Reference	SSM72132
Models	LR2 / L359 Range Rover Evoque / L538
Title	M66 manual transmission turret housing incorrect part - LR022071 LR072971
Category	Driveline
Last modified	23-Dec-2014 00:00:00
Symptom	503000 Automatic Transmission Engagement Concerns
Attachments	A1.pdf

LR022071

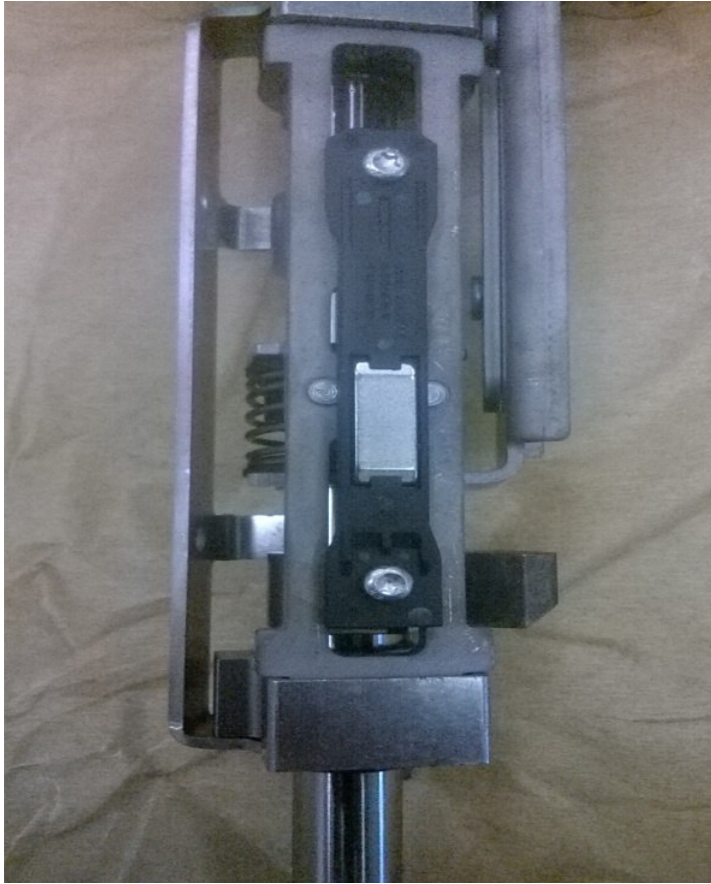
Cause: In March 2013 a hall effect sensor turret was introduced, but was not given a service part number. Dealers ordering part No.LR022071 may have either the an inductive or hall effect Turret supplied. This may be incorrect for the vehicle being repaired.

- LR022071-Inductive sensor Turret
- LR072971-Hall effect sensor Turret.
